P-51D MUSTANG

TECHNICAL UPDATE

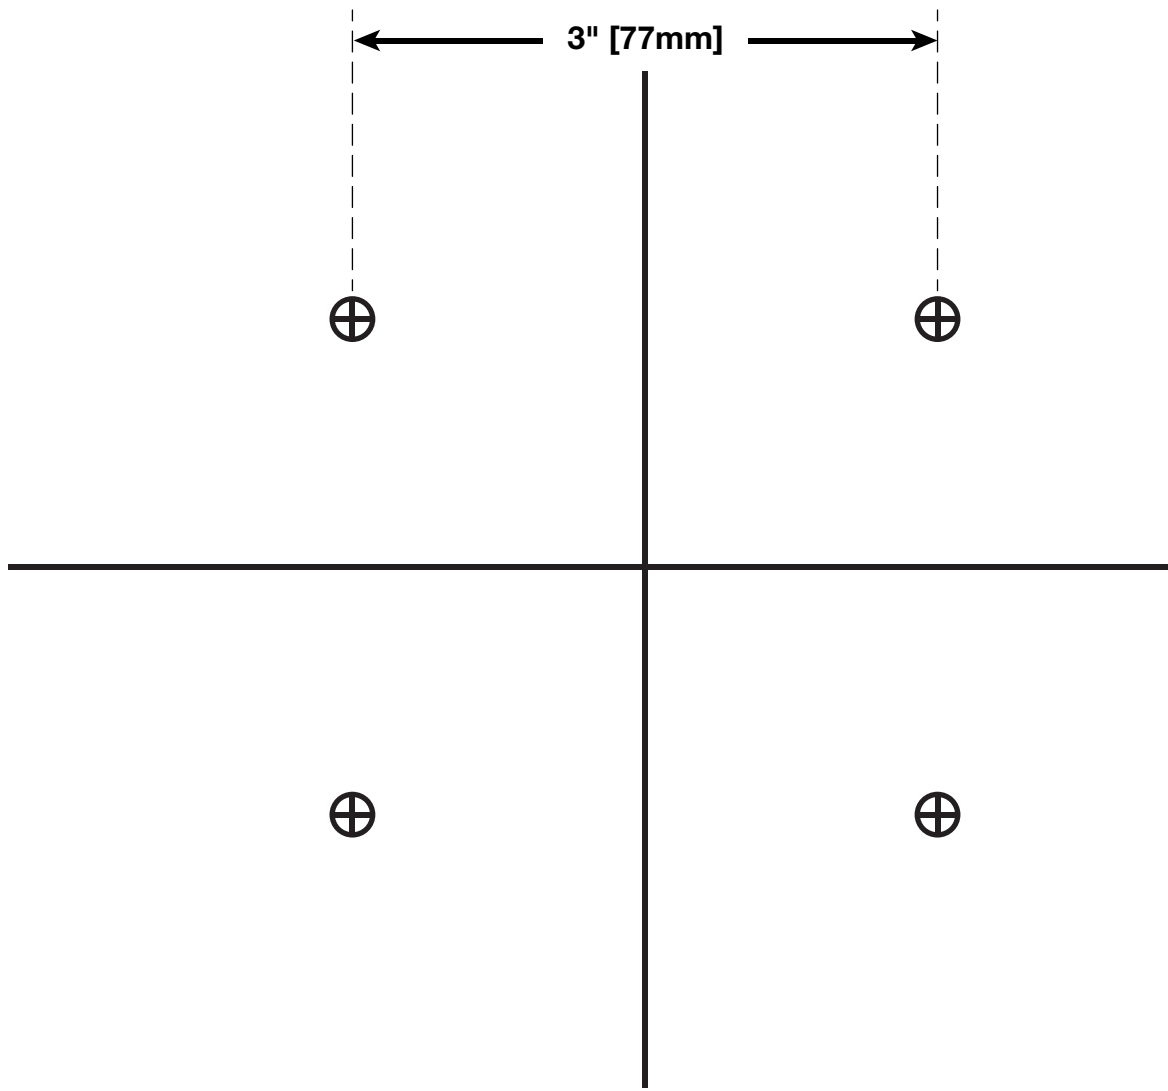
Since the Top Flite Giant P-51 ARF was released, new gas engines have become available. The DLE55 Rear Exhaust (DLEG0455) with the stock muffler, the DLE61 Side Exhaust (DLEG0061) with the J'TEC JTCDL61WPTF Wraparound Pitts muffler (JTJCG2173) and the O.S. GT60 (OSMG1561) with the J'TEC JTCOSGT60WPTF Wraparound Pitts muffler and 2" [51mm] Standoffs (OSMG8962) work well. Included are the bolt patterns for the gas engines along with the bolt pattern for the Rimfire 65cc electric motor.

1. Cutout the bolt pattern for the engine to be installed and tape it to the front of the firewall aligning the embossed lines on the firewall with the lines on the bolt pattern. The lower two blind nuts may need to be removed and a short piece of 5/16" [8mm] wooden dowel glued in the holes.

3. Drill a 13/64" [5mm] hole through the firewall and plywood spacers at each of the appropriate locations marked with an "X" or "+".
